**Re: Breesport Solar Project  
625 Breesport Road, Horseheads, New York  
Review of Stormwater Management Plan**

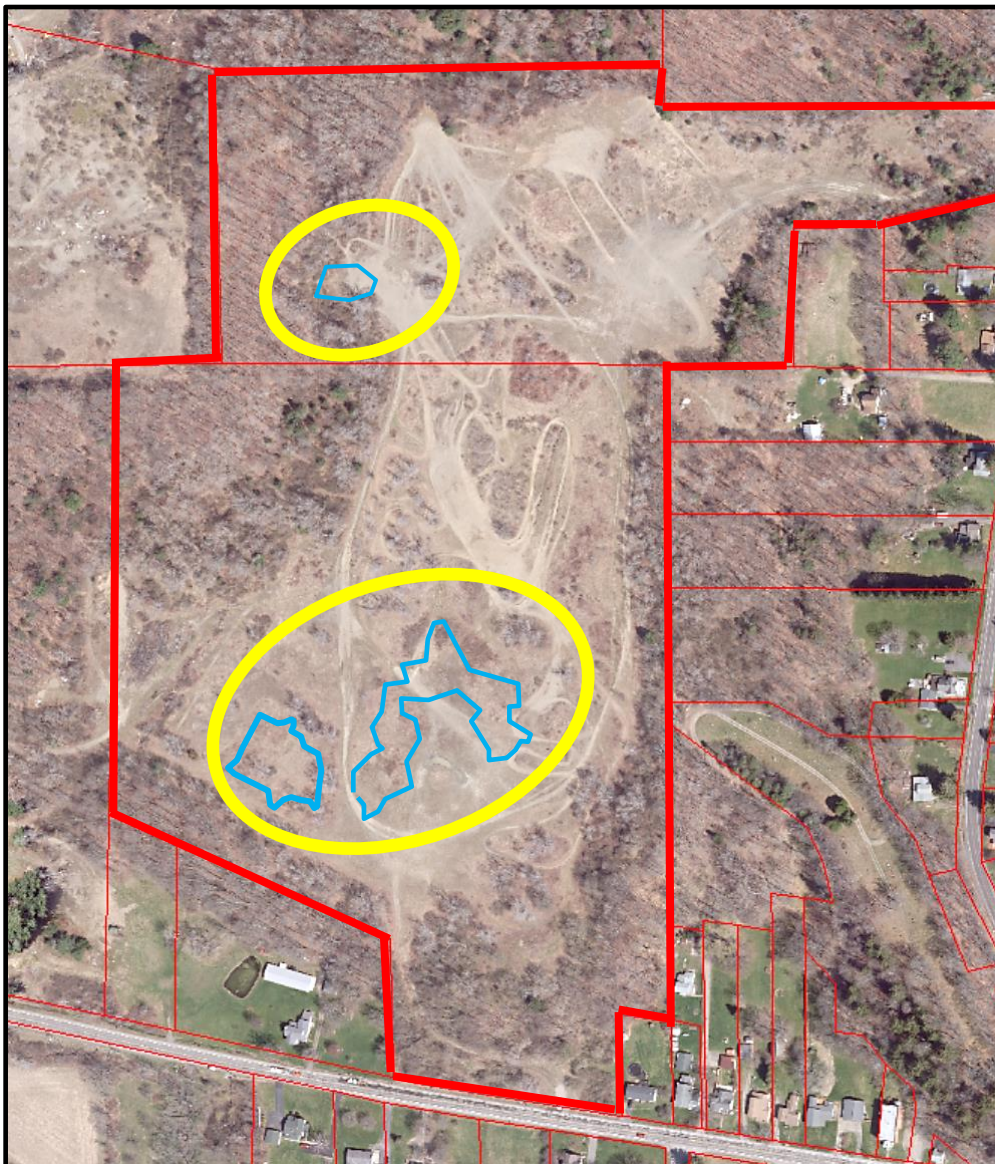
1. The aerial photo is of the project site and was taken in 2018. The borders of this property are shown approximately with thick red lines. Of note, some significant topographic depressions exist within portions of this property are remnants of the past gravel mining operation. It is expected that these depressions receive runoff from the adjacent hillside areas, temporarily store this runoff, and eventually infiltrate this stored runoff.

These depressions currently provide stormwater management benefits, including reducing peak flow rates reaching adjacent downhill areas. Refer to the areas within the yellow ovals for the approximate location of the topographic depressions and the blue lines for the rough borders of these depressions.

It is requested that the Applicant provide the following information and include this in the plans and SWPPP.

- A description of the proposed changes within this area (including to the existing depressions)
  - A description of how the proposed development (including the installation of the proposed solar panels) will not reduce the current function of this area for stormwater management.
